**Cork County Council****Planning and Development Act 2000 (as amended)****Planning and Development (Strategic Infrastructure) Act 2006**

Planning Authority submission on further information received by An Bord Pleanála.

| <b>An Bord Pleanála Ref. No:</b>   | ABP Ref. 312606-22  |
| <b>Applicant:</b>                  | Ballinagree Wind DAC  |

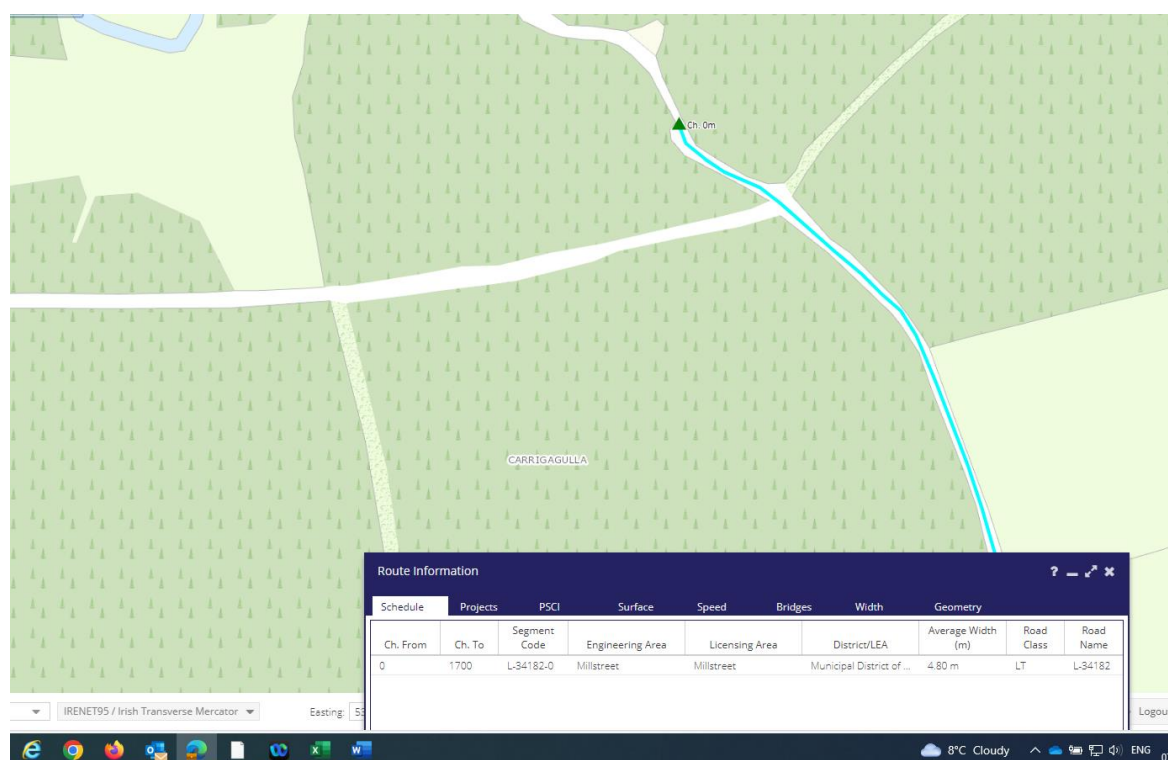
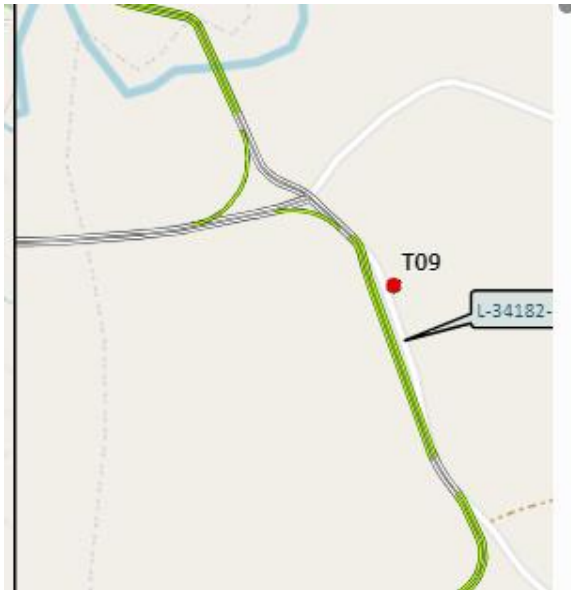
There seems to be some confusion on the Location of Turbine 9 in relation to Public Road Below is the screen shot from the Public Road Register – the L-34182 is highlighted in blue. When compared to the second screenshot below as extracted from Page 43 of the response to RFI it is clear that the public road continues north past T09.

Location of Turbine 9 in relation to Public Road.

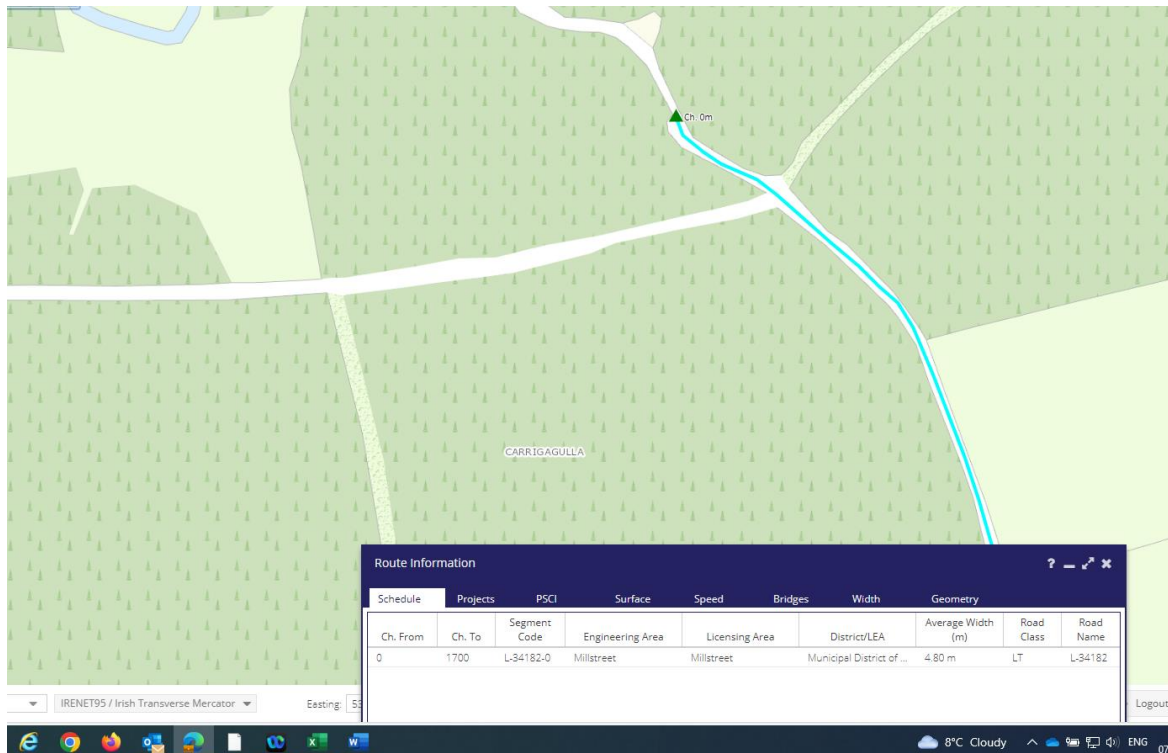
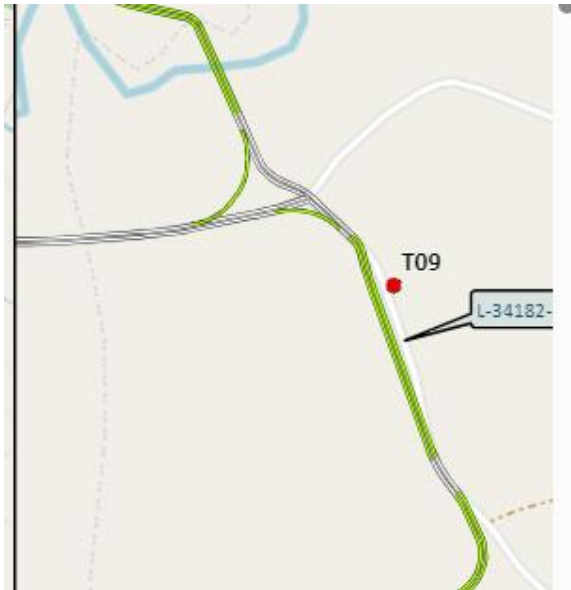
There seems to be some confusion on this matter. Below is the screen shot from the Public Road Register – the L-34182 is highlighted in blue. When compared to the second screenshot below

as extracted from Page 43 of the response to RFI it is clear that the public road continues north past

T09. I accept that this surface may be poor or non-existent but none the less it is legally registered as a public road. The applicant must address this issue – it is not acceptable to simply dismiss it as an ‘error in the shapefile’.
